Access Compliance Report

Public Rights-of-Way

Intersection ID: 6806	Main Street: UNIVERSITY_EAST_DR	Cross Street: E_W_T_HARRIS_BV	Location: SW
ADA ID: 6E16E4E9055A	Ramp Type: Perp	Initial Pass/Fail: Fail	Overall Compliance: No
		Severity Score: 12.5

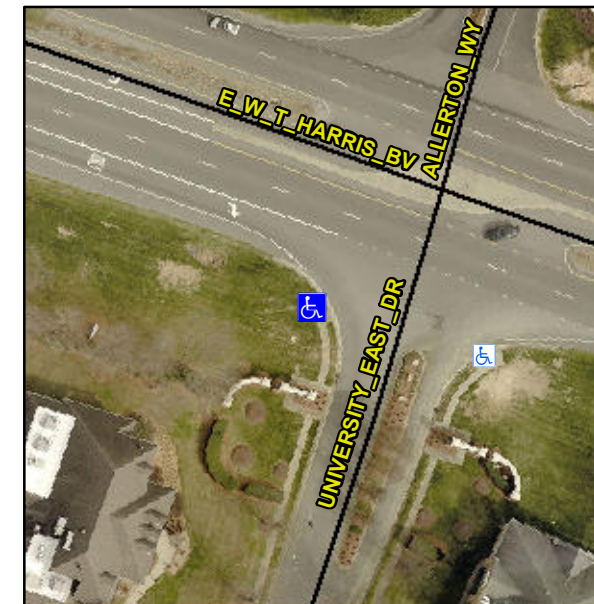
Not Found, R304.2.2

Compliance	Description	Data	Compliance	Description	Data
N/A	Ramp Length (in)	61.0	No	Ramp Slope (%)	8.4
Yes	Ramp Width (in)	48.0	Yes	Ramp XSlope (%)	1.3
N/A	Flare Type LT	N/A	N/A	Flare Type RT	N/A
N/A	Flare Slope LT (%)	N/A	N/A	Flare Slope RT (%)	N/A
N/A	Flare Traversable LT?	N/A	N/A	Flare Traversable RT?	N/A
N/A	Landing Length (in)	N/A	N/A	DWS Provided?	N/A
N/A	Landing Width (in)	N/A	N/A	DWS Contrast?	N/A
N/A	Landing Slope (%)	N/A	N/A	DWS Length (in)	N/A
N/A	Landing X Slope (%)	N/A	N/A	DWS Full Width?	N/A
N/A	Landing Curb? (Y/N)	N/A	N/A	DWS Offset (in)	N/A
N/A	Shared Landing?	N/A			
N/A	Gutter Ponding?	N/A	N/A	Gutter Slope (%)	N/A
N/A	Gutter Lip Ht (in)	N/A	N/A	Gutter X Slope (%)	N/A
N/A	Painted X Walk1?	No	N/A	Painted X Walk2?	N/A
	X Walk 1 Direction	To SE		X Walk 2 Direction	N/A
N/A	X Walk 1 Width (in)	N/A	N/A	X Walk 2 Width (in)	N/A
	X Walk 1 Slope (%)	3.2		X Walk 2 Slope (%)	N/A
	X Walk 1 X Slope (%)	0.7		X Walk 2 X Slope (%)	N/A

Remove & Replace Entire Ramp.
